MYERS CHUCK HARBOR FACILITIES PROJECT NO. K-31521

AS BUILT

START : MAY 31, 1985
STOP : JULY 9, 1985
CONTRACTOR : DAWSON CONSTRUCTION CO.
PROJECT ENGINEER : MARK HALVORSEN
DATE : JULY 19, 1985

Remove 16'-0" of existing 4x10x26'-0" Stringer & install 16' of flotation planks (7' plank & 9' plank)

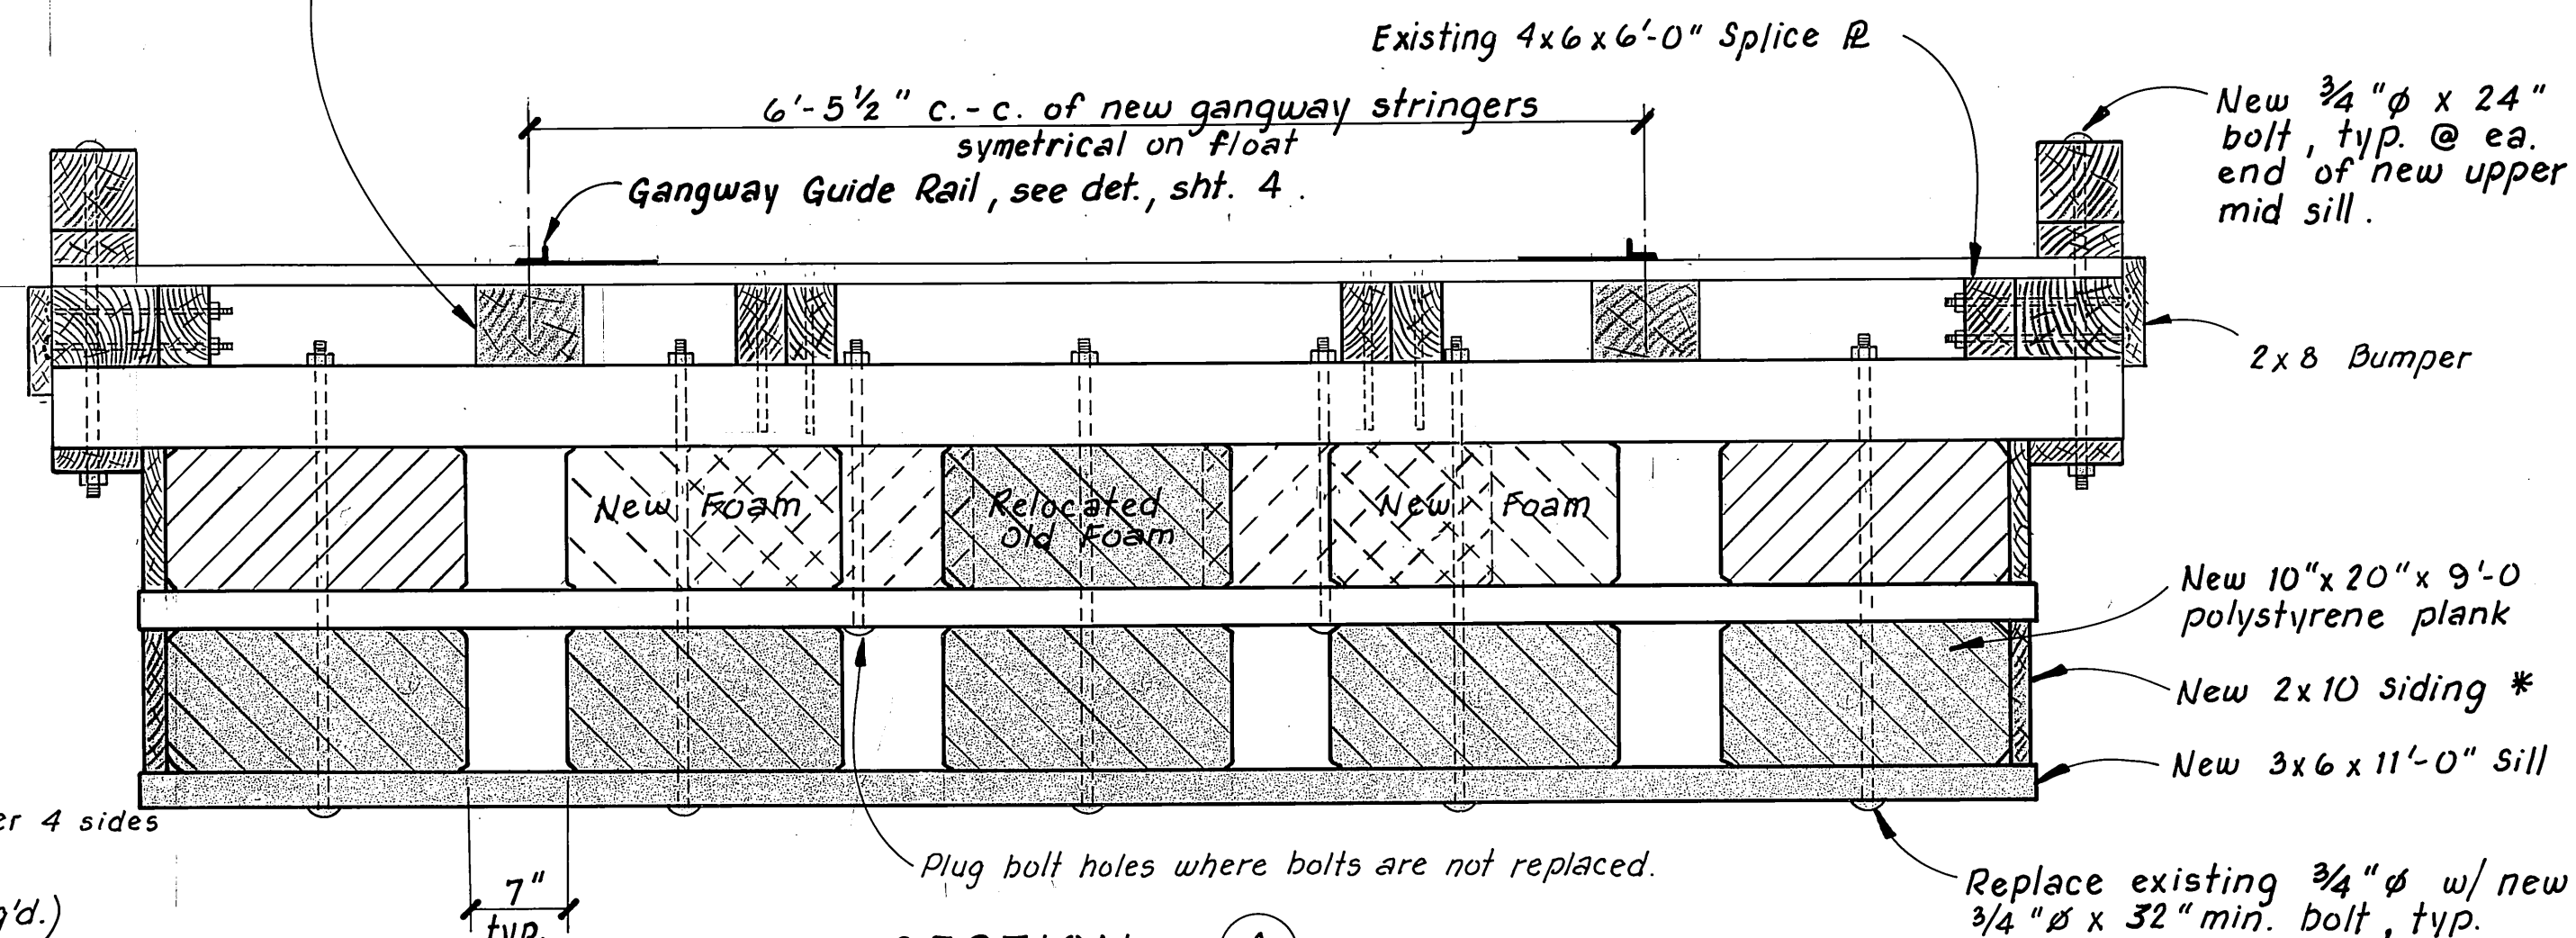
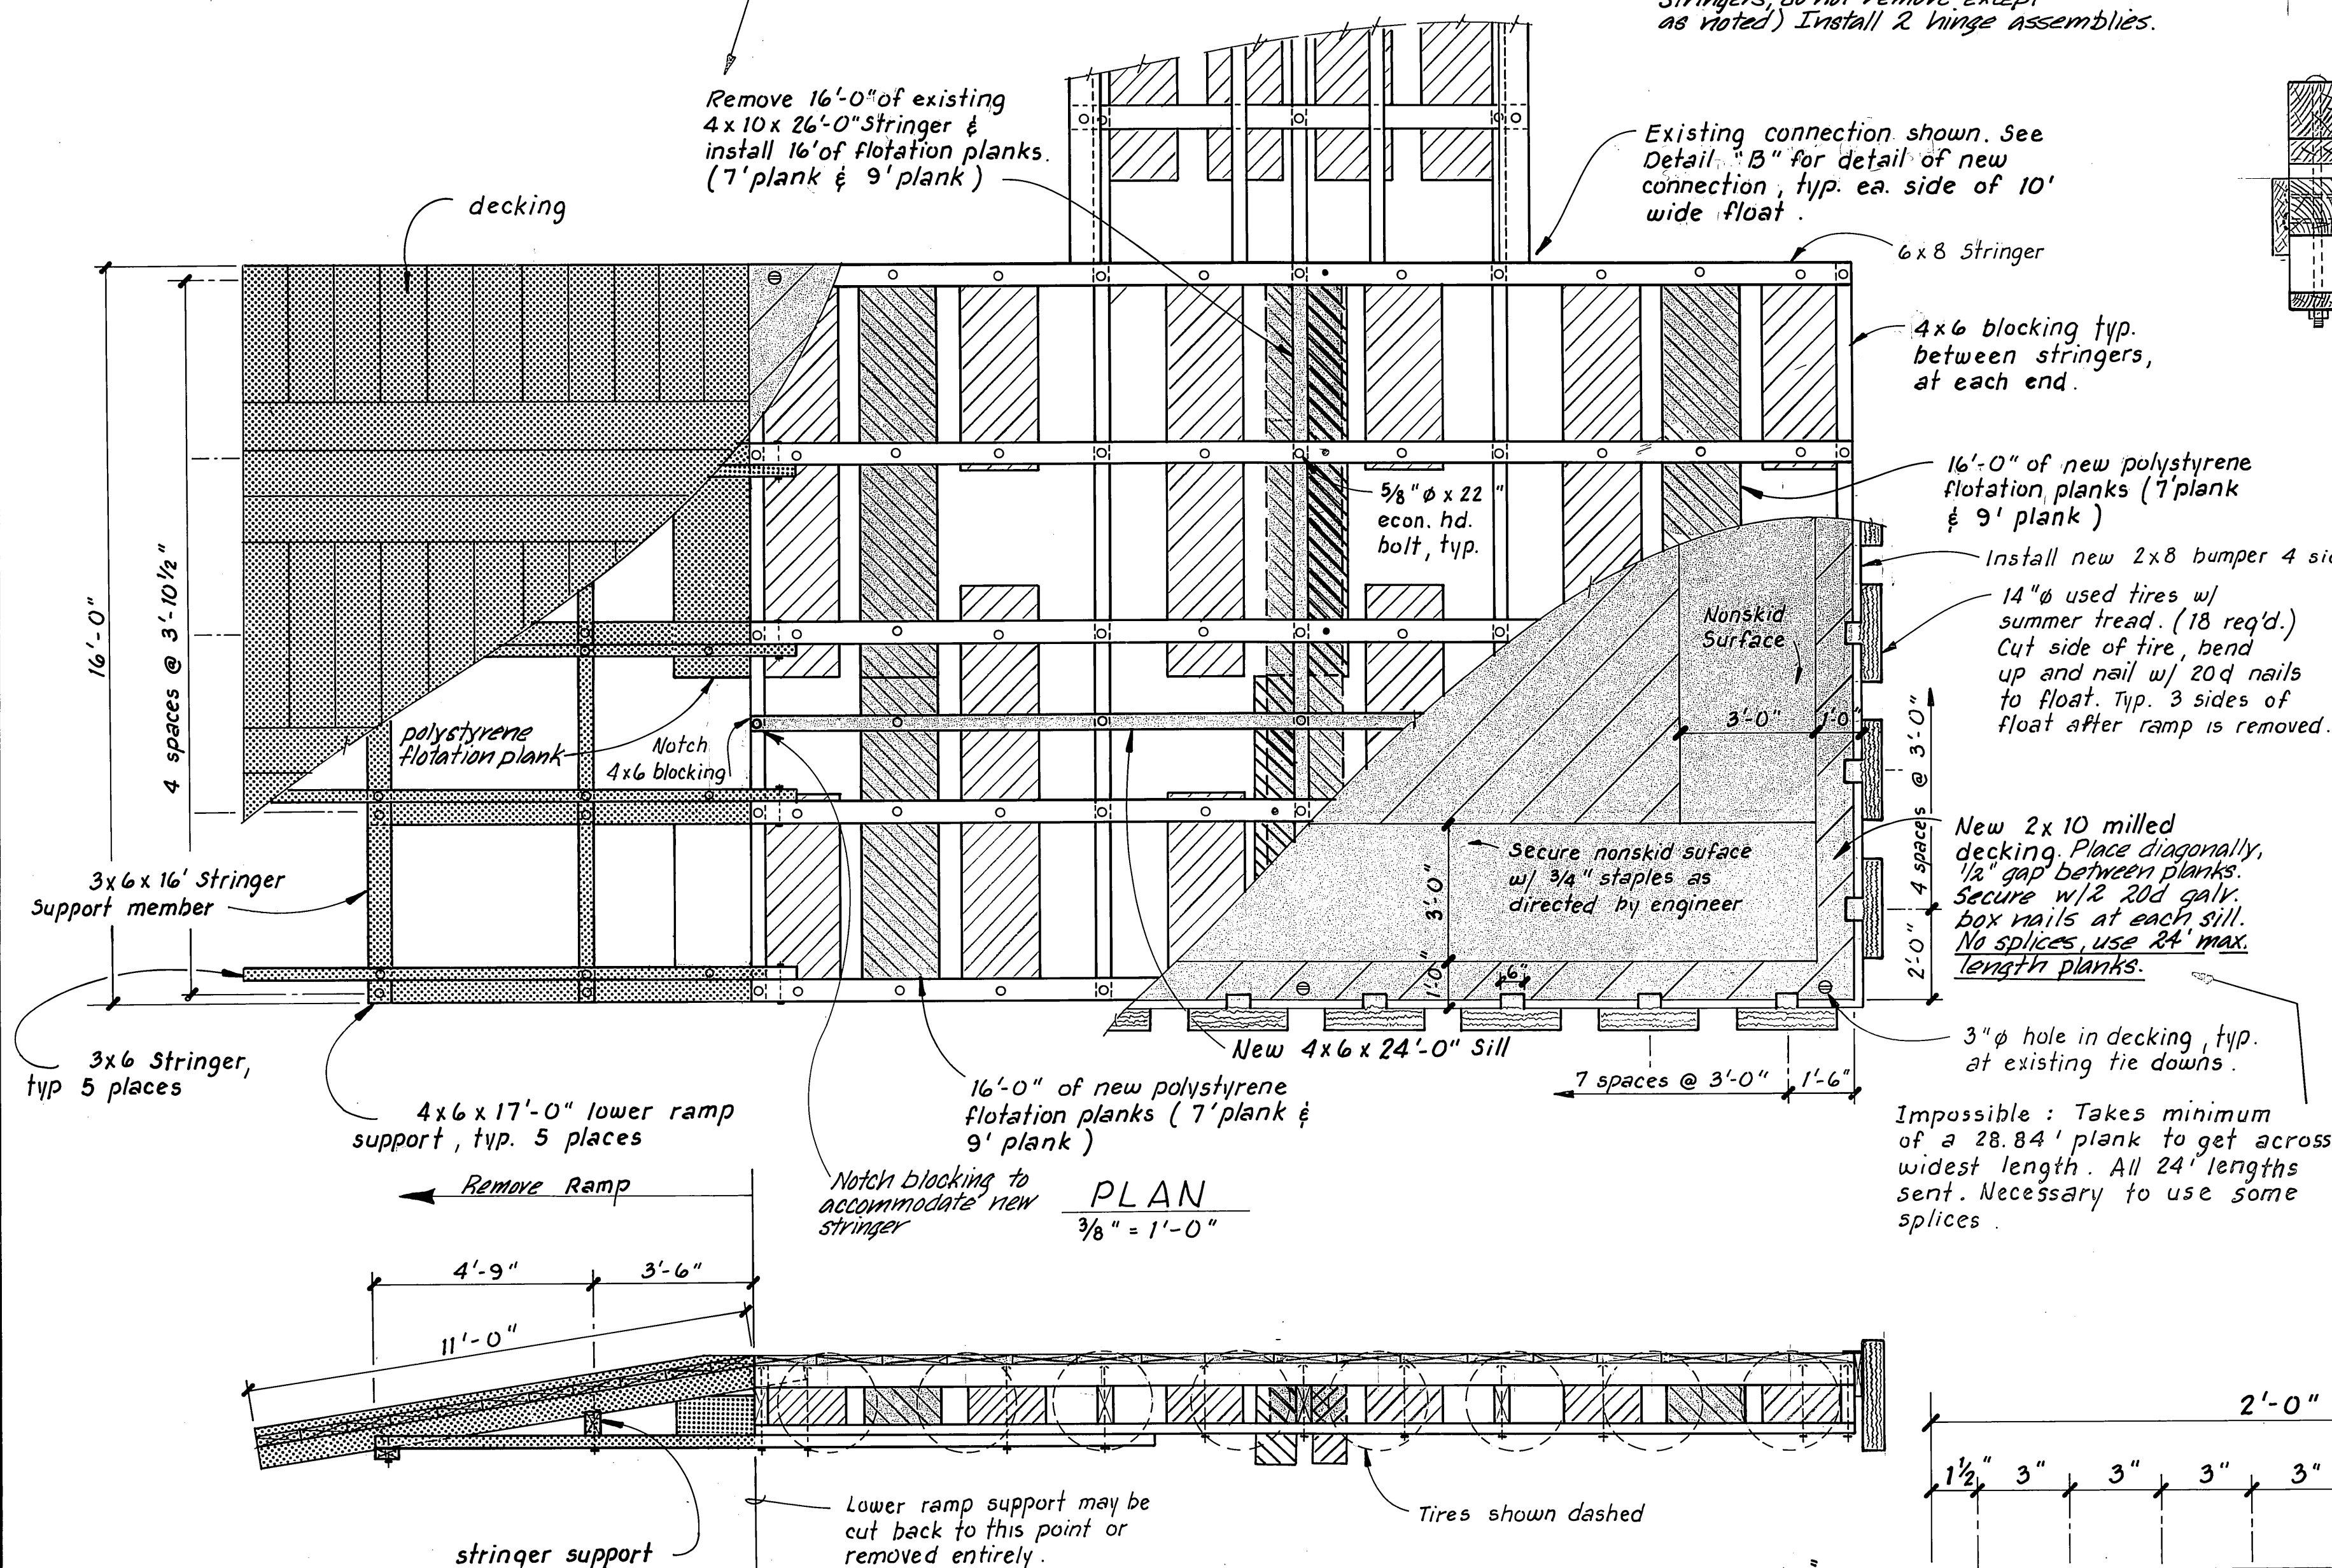
Left this stringer in place for added support.
All underwater portions of the 4x10 Sills & all of the bottom stringers are badly bug eaten. The existing foam is also badly eaten. The bottom ends of the galv. bolts are corroding out. The foam billets this location installed on edge.

Extra piece of new foam installed in this pontoon. Came from next pontoon in line, see note on page 2.
